## ORIGINATION FORM

### Proposed Revisions to a Standard Plans Index (Please provide all information — Incomplete forms will be returned)

Index Number: 715-001

Index Title: Conventional Lighting

METAL POLE WIRING DETAIL

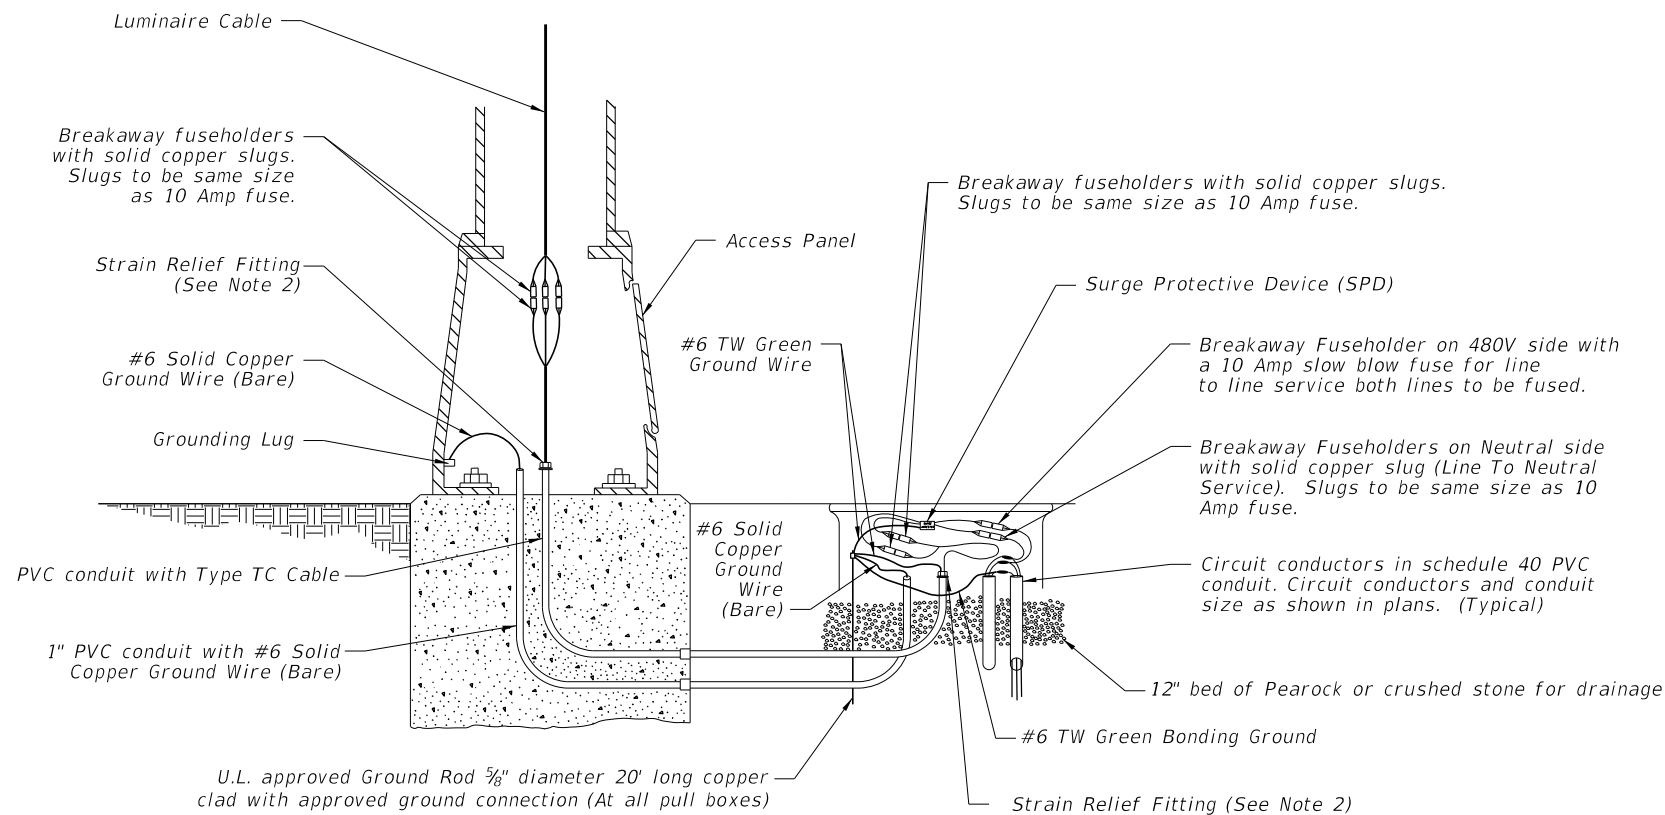
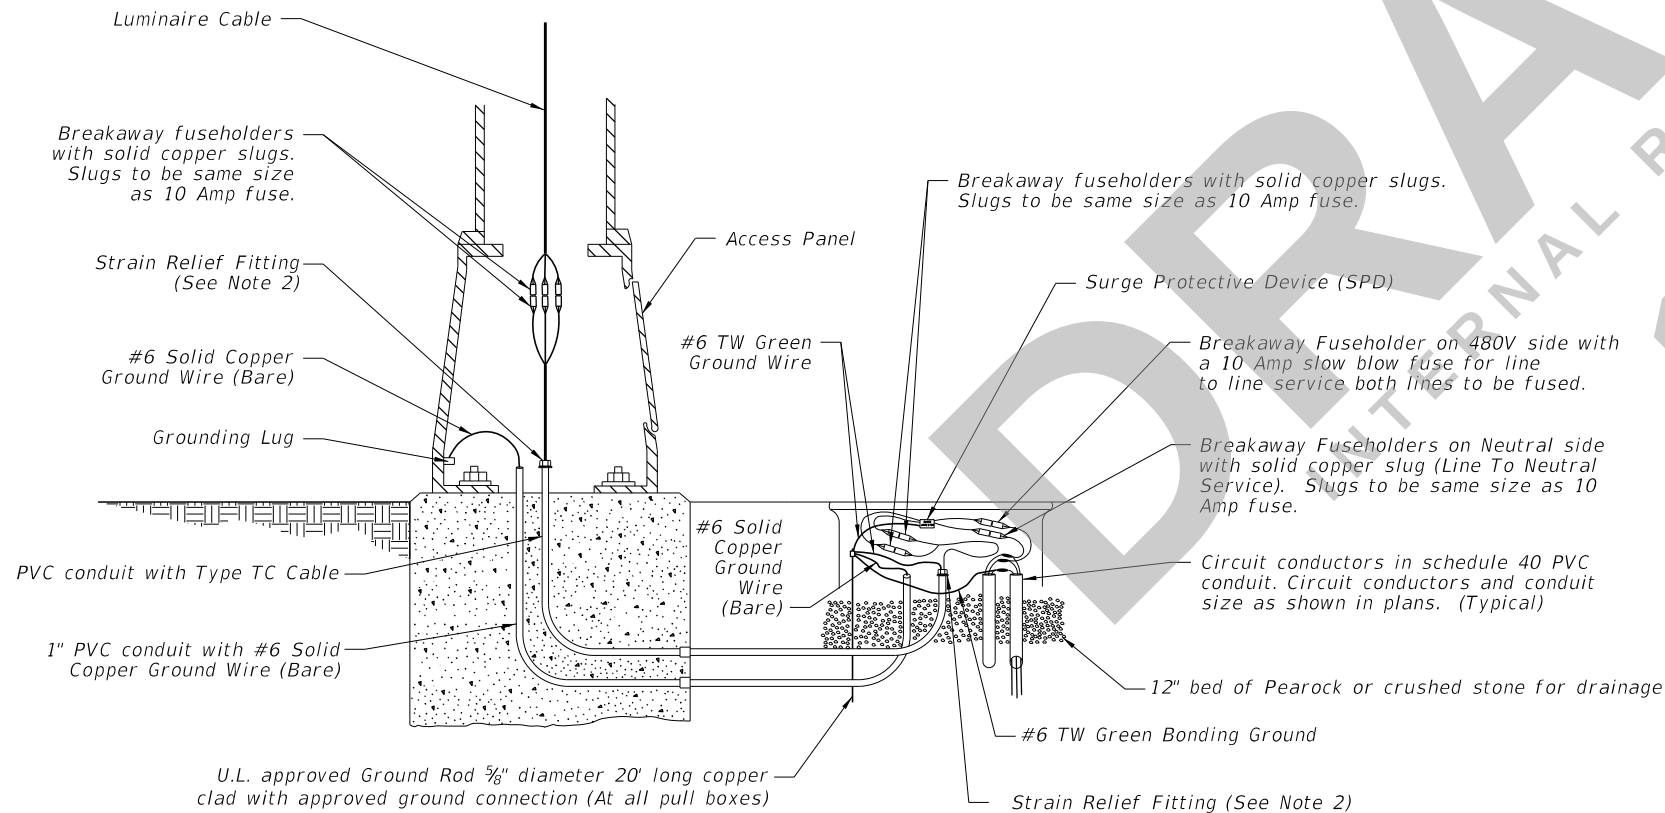
Sheet 1: Updated Note 1 for Concrete Barrier and bridge mount. Provided additional wiring detail, a reference to 715-002, and new information of where breakaway fuse holders fit inside of pole.

1. Concrete Barrier and Bridge Mounted Poles: Place wiring system following conduit layouts and requirements of Index 715-002. Follow additional requirements of Specification 992. For wiring and devices shown inside of pull boxes on this sheet, place inside of embedded junction boxes instead. Place the vertical breakaway fuseholders inside the pole, at the handhole location.

2. Provide enough cable length to allow for removal of fuseholders from the transformer base, pole base, or pullbox for maintenance. Remove slack from the luminaire cable to provide tension on the fuseholders in breakaway pole designs. Pull excess cable into pull box tighten strain relief fittings or cable clamps at both ends of conduit to prevent cable from slipping.

METAL POLE DETAIL

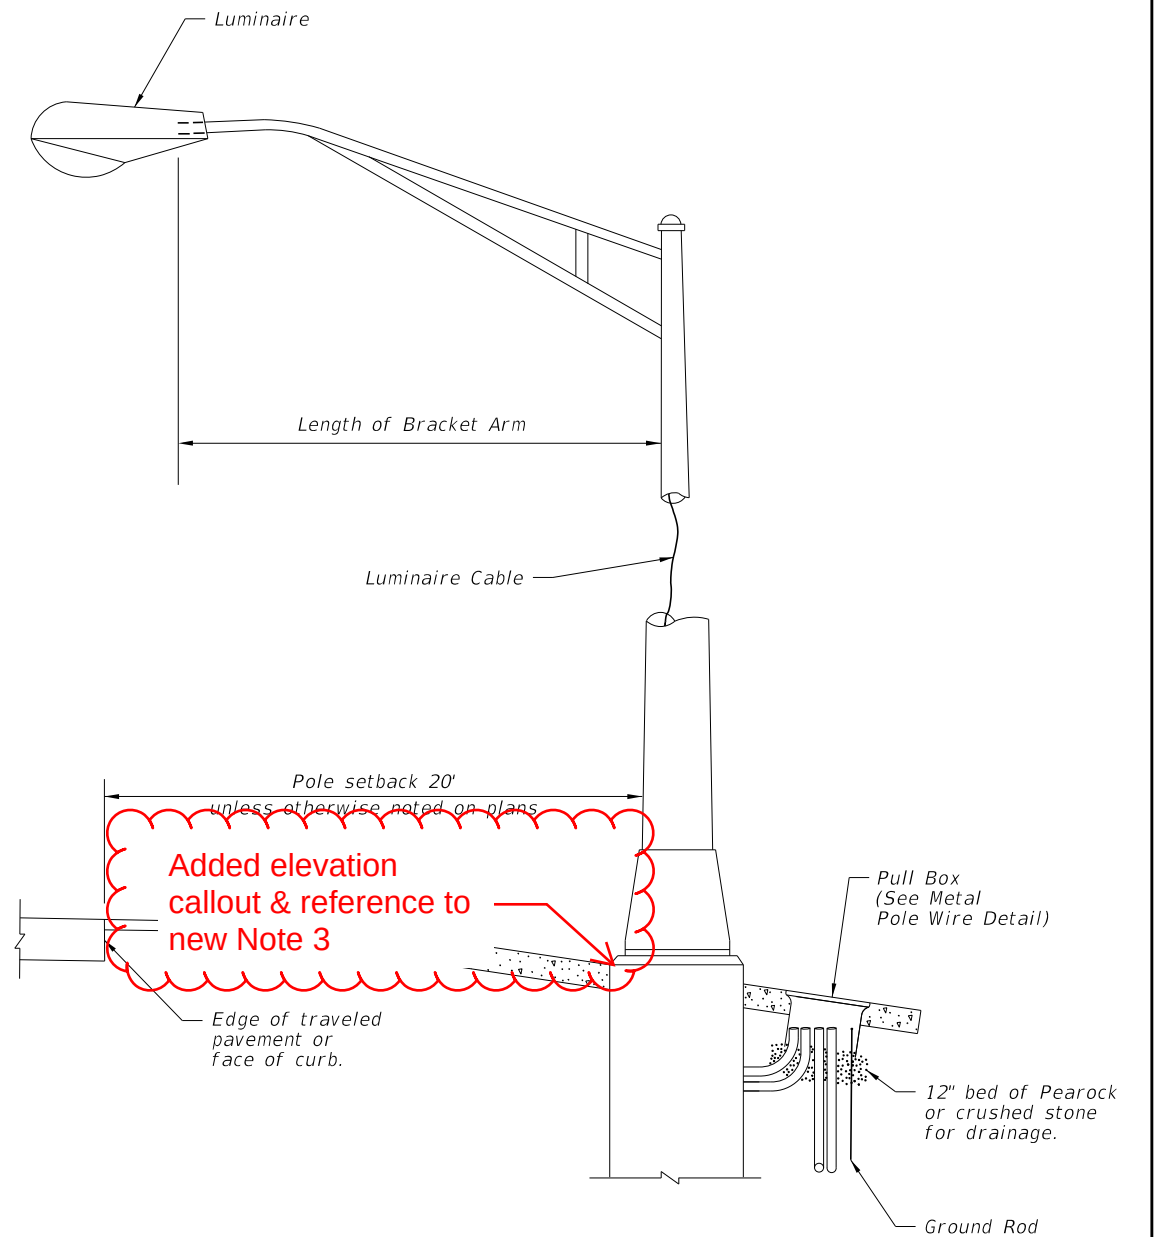
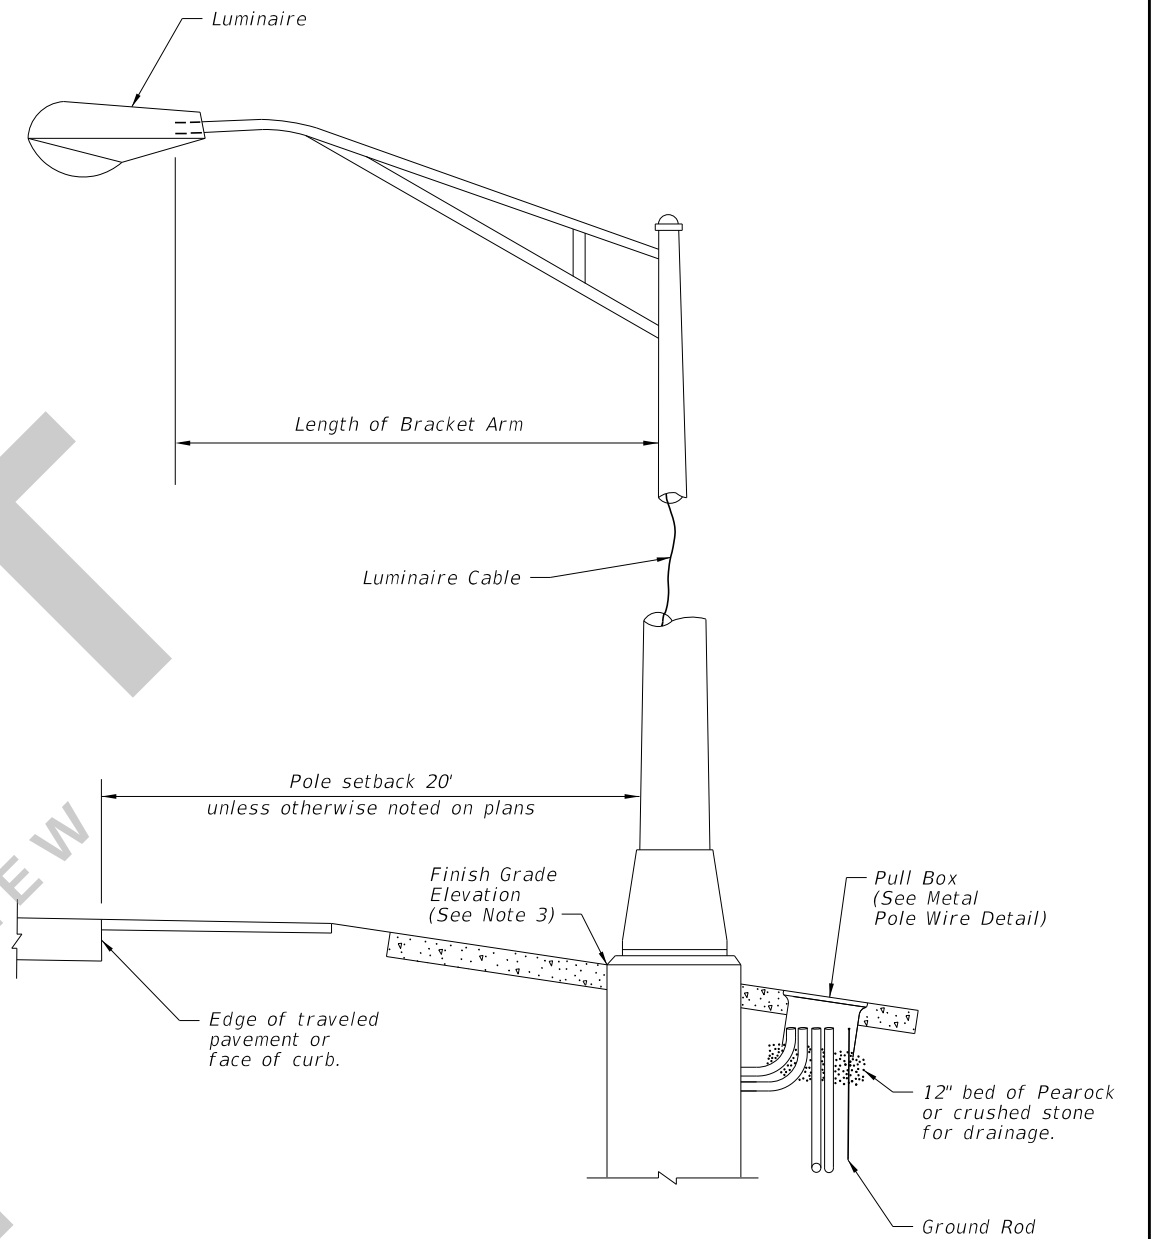
Added callout and new Note 3 to explain that the top of the concrete foundation is flush with the finish grade elevation on the side nearest to traffic lane. Added vertical tolerance.

Added additional language to clarify wiring for 715-002 including breakaway fuse holder location

Added new Note 3 for required foundation elevation.

3. Align concrete foundation with the finish grade elevation on the side nearest the traffic lane. Relative to the finish grade, the vertical tolerance is -0 inch, +2 inch.
